Submission Regarding Development 48 Fisher Road Dee Why

Application No. DA2019/1200

Address Lot A DP 303009 48 Fisher Road DEE WHY

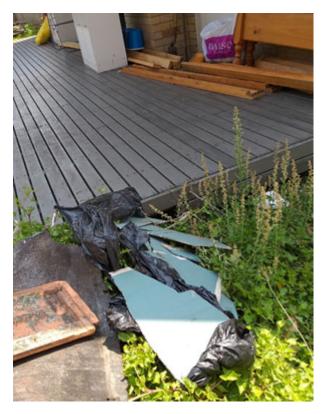
The garage has been partly demolished and there has been no effort to ensure that asbestos material has been properly removed. There is asbestos material left lying in the grass.

I include a photo here; the green material in the foreground on top of the garbage bags is asbestos sheeting from the garage structure.
